**TOWN OF ABINGDON, VIRGINIA
HISTORIC PRESERVATION REVIEW BOARD
WEDNESDAY, August 9, 2022 – 5:15 P.M.
COUNCIL CHAMBERS, MUNICIPAL BUILDING
CONTACT: GABRIEL CRISTOFARI
email: gcristofari@abingdon-va.gov Phone: 276-628-3167**

- 1. Certificate of Appropriateness – Nathan Berg, Wallberg Construction, 190 E. Main Street, Abingdon, VA.; applicant. Application for Certificate of Appropriateness for exterior change. Located at 201 E. Main Street, Abingdon, VA 24210. Tax Map No. (013-1-64)**

SUBJECT: REQUEST FOR A CERTIFICATE OF APPROPRIATENESS FOR A EXTERIOR CHANGE

West Elevation

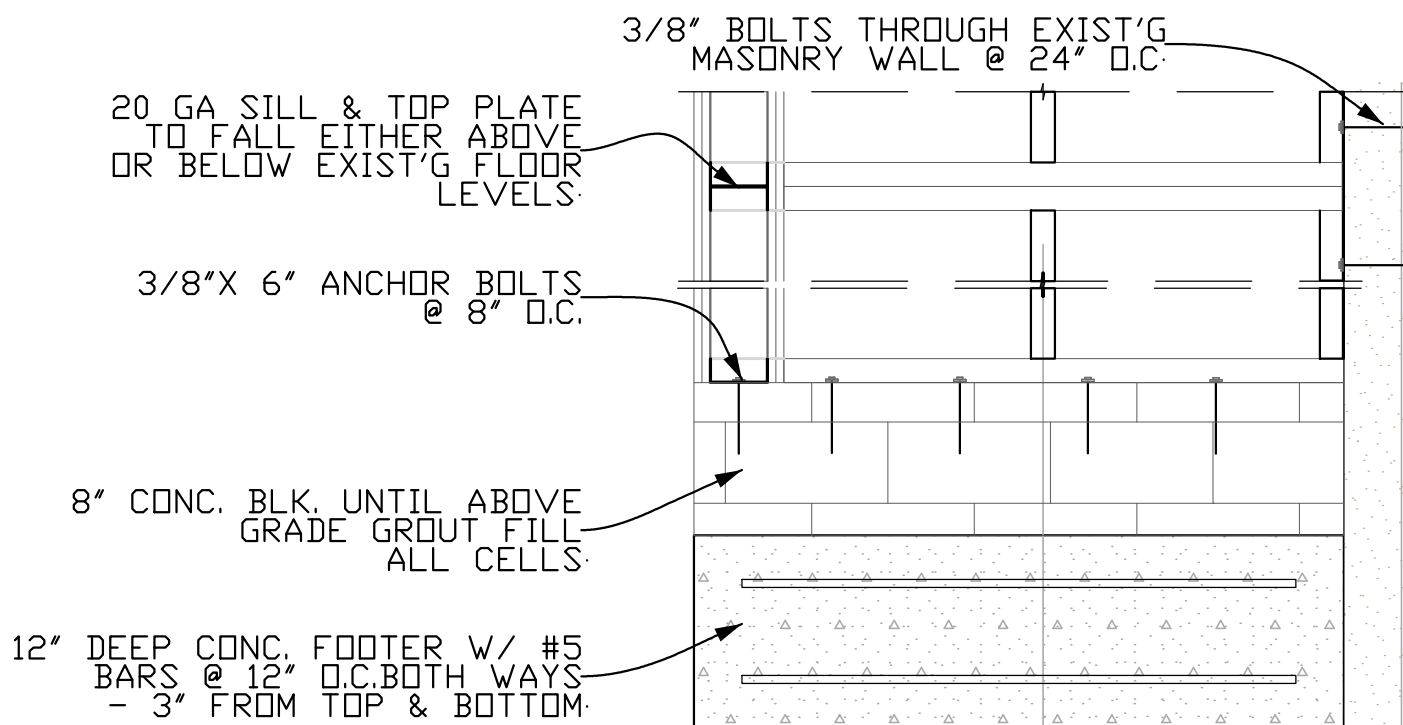
Widen the previously approved dumb waiter shaft visible from Court Street and Plumb Alley by 30" westward for a double-walled vent pipe for the hood system. The proposed shaft will sit away from the face of the structure. The applicant previously anticipated being able to use a single-wall vent, which would have fit inside the dumbwaiter shaft as designed, but fire code has precluded them from doing that. Widening the shaft would result in the covering of windows (not visible from any public vantage point) located immediately to the right of the dumb waiter shaft seen slightly from Plumb Alley.

Attach a 22 in. diameter pipe per the description of David Berg on 8/3/2022 to the outside of the dumb waiter shaft. The pipe would be prefinished the same color as the dumb waiter shaft exterior.

Upon discussing the project with Mr. Statzer, Town of Abingdon's Building Official and a site visit to confirm, the shaft either is constructed of brick or a brick veneer. Mr. David Berg mentioned the dumb waiter shaft on 8/3/2022 was stucco. If the dumb waiter shaft has a brick veneer it may be unwise to attach the metal pipe to the exterior of the shaft. Veneers have minimal to zero internal structure strength due to a lack of interlocking courses.

PROPOSED
VENT SHAFT
30" x 30"
Finish to match
existing masonry
